# UNITED STATES PATENT AND TRADEMARK OFFICE

APPLICATION NO.	FILING DATE	FIRST NAMED INVENTOR	ATTORNEY DOCKET NO.	CONFIRMATION NO.
09/374,681	09/19/2002	CRAIG H. BAKER	81762/210	4027
7590	06/02/2005		EXAMINER	
GUNNER G. LEINBERG, ESQ. NIXON PEABODY LLP CLINTON SQUARE P.O. BOX 31051 ROCHESTER, NY 14603				TSUKERMAN, LARISA Z
		ART UNIT	PAPER NUMBER	2833

<b>Office Action Summary</b>	<b>Application No.</b>	<b>Applicant(s)</b>	
	09/374,681	BAKER ET AL.	
	<b>Examiner</b>	<b>Art Unit</b>	
	Larisa Z. Tsukerman	2833

## DETAILED ACTION

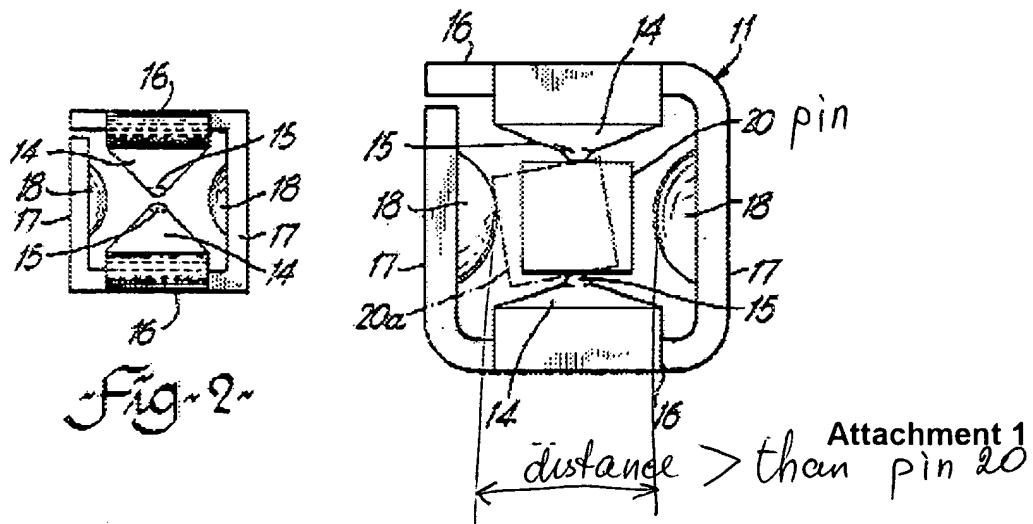
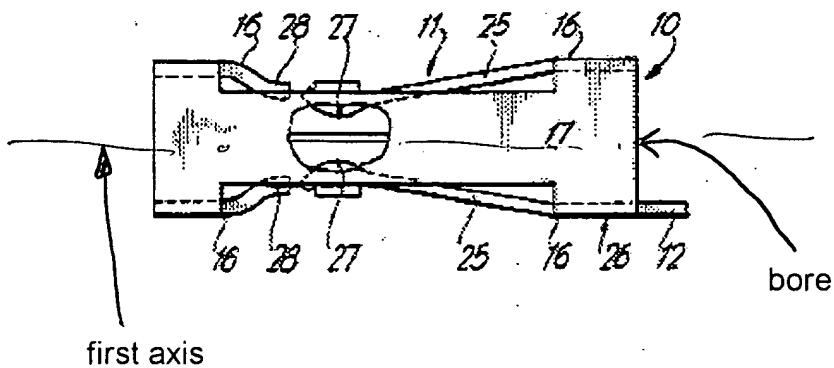
an electrically conductive body 11 having a pin contact engaging bore (not marked, see Attachment) which extends at least partially along a first axis, the body 11 comprising:

at least two pin contact arc receiving elements 18 (see Attachment 1, read on applicant's left and right guide portions 18) extending into the bore, wherein the arc receiving elements 18 are spaced apart across the bore and having a distance that is greater than a maximum transverse dimension of the pin contact 20 (shown in Fig.3), and

a plurality of conductive spring contacts 14 spaced from and not aligned with the arc receiving elements 18 in a direction along the first axis of the bore and which extend in towards the first axis.
